Economic Commission for Europe**Inland Transport Committee****World Forum for Harmonization of Vehicle Regulations****Working Party on Lighting and Light-Signalling****Eighty-seventh session**

**UN Regulations on Light Sources and the
Consolidated Resolution on the Common
Specification of Light Source Categories****Proposal for amendment 9 to the Consolidated Resolution on
the common specification of light source categories (R.E.5)****Submitted by the expert from the International Automotive Lighting
and Light-Signalling Expert Group (GTB)***

Figure 1*
Main Drawing

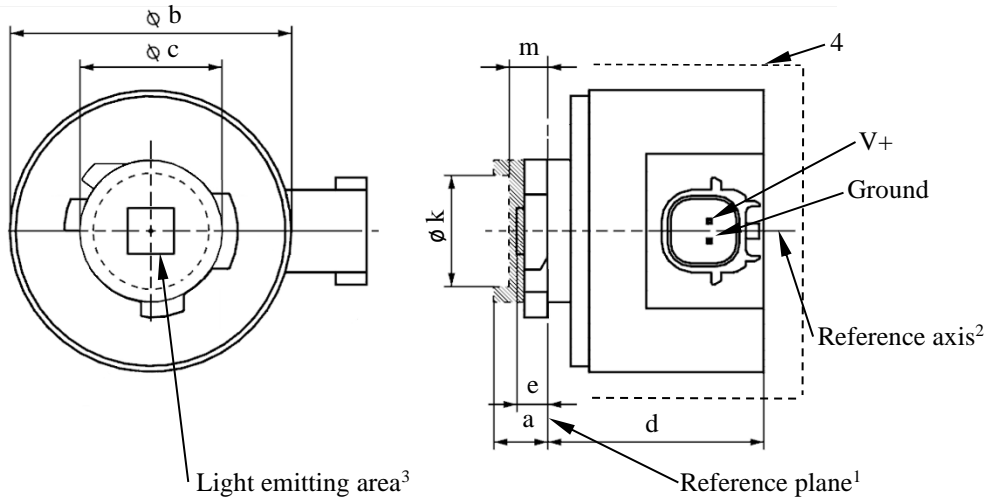
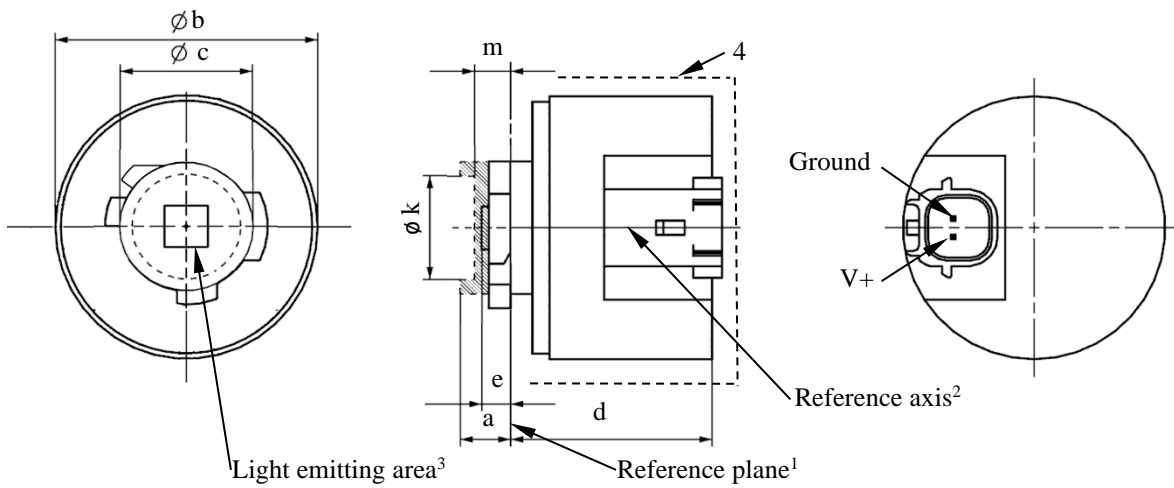
Annex 3, Sheets Lx6/1 to 6, amend to read:

^{5/} The emitted light shall be red for LR6A and LR6B, **white for LW6A and LW6B, and amber for LY6A and LY6B.**

^{10/} **Operated in flashing mode for 30 minutes (frequency = 1.5 Hz, duty cycle 50 per cent ON, 50 per cent OFF). Measured in the ON-state of flashing mode after 30 minutes of operation.**

Figure 2

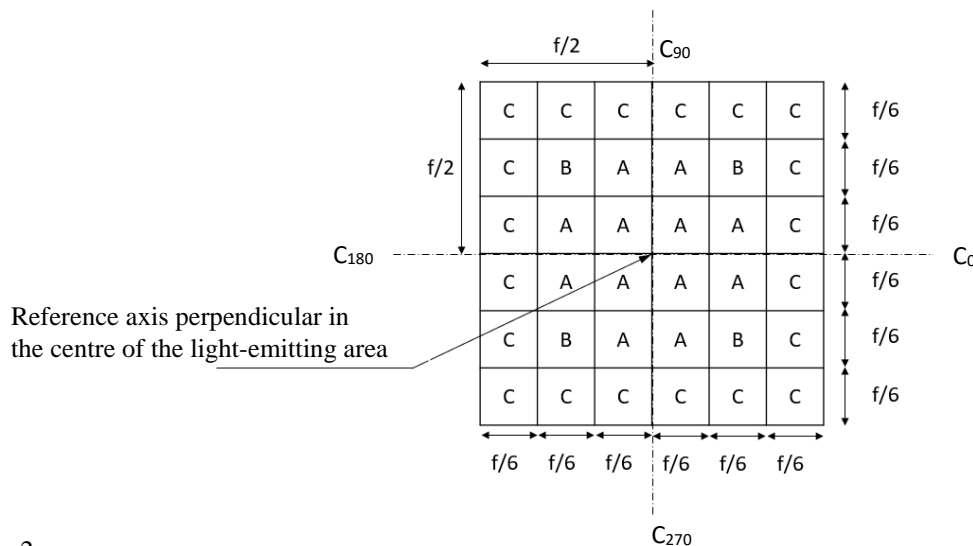
<i>Category</i>	<i>Area(s)</i>	<i>LED light sources of normal production</i>	<i>Standard LED light sources</i>
LR6A, LR6B LY6A, LY6B	Each A individually	> 3% < 10 %	> 4% < 10%
	Each B individually	> 3% < 10%	> 3% < 10%
	All A and B together	> 70%	> 75%
	Each C individually	< 2%	< 2%
	All A, B and C together	> 90%	> 90%
LW6A, LW6B	Each A individually	> 3% < 10 %	> 3% < 10%
	Each B individually	> 3% < 10%	> 3% < 10%
	All A and B together	> 65%	> 70%
	Each C individually	< 3%	< 3%
	All A, B and C together	> 90%	> 90%

Figure 3
Set-up to measure the luminous intensity distribution

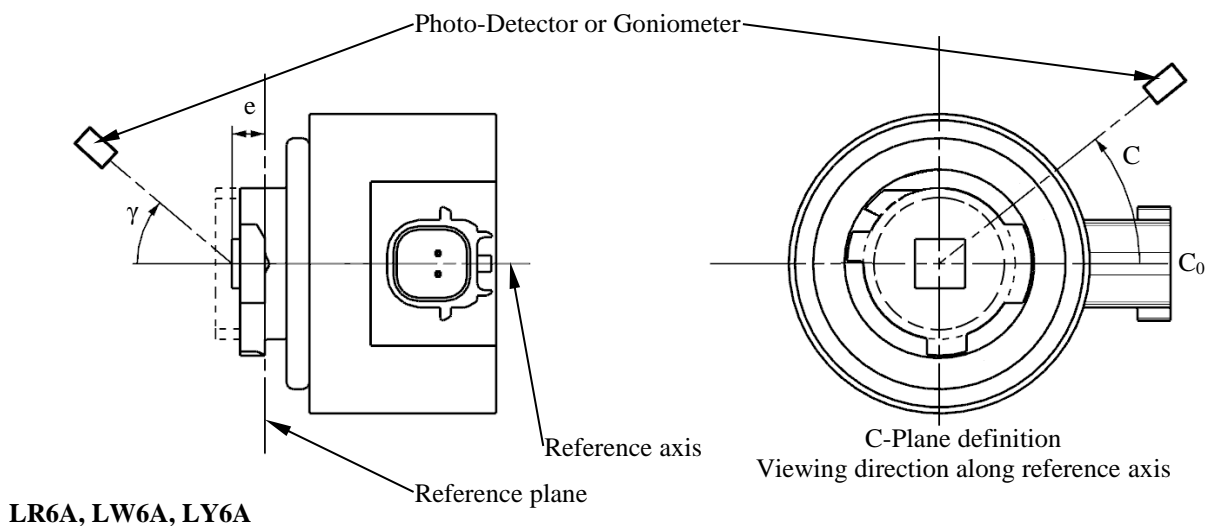
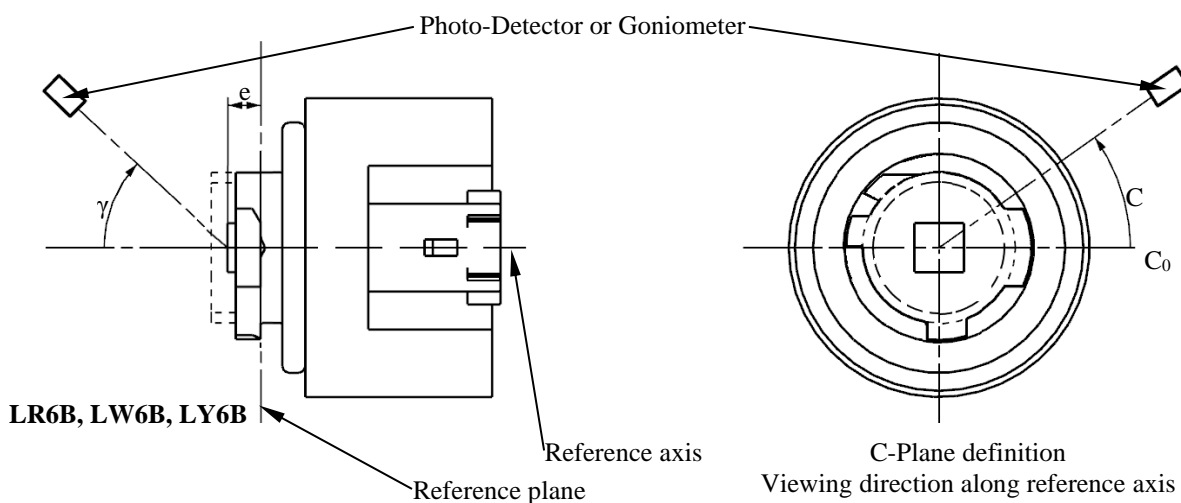
<i>Angle γ</i>	<i>LED light sources of normal production</i>		<i>Standard LED light sources</i>	
	<i>Minimum Intensity in cd /1000 lm</i>	<i>Maximum Intensity in cd/1000 lm</i>	<i>Minimum Intensity in cd /1000 lm</i>	<i>Maximum Intensity in cd /1000 lm</i>
0°	200	425	250	390
15°	190	415	240	370
30°	170	380	220	335
45°	145	310	180	275
60°	85	245	105	220
75°	0	160	0	150
90°	0	70	0	65
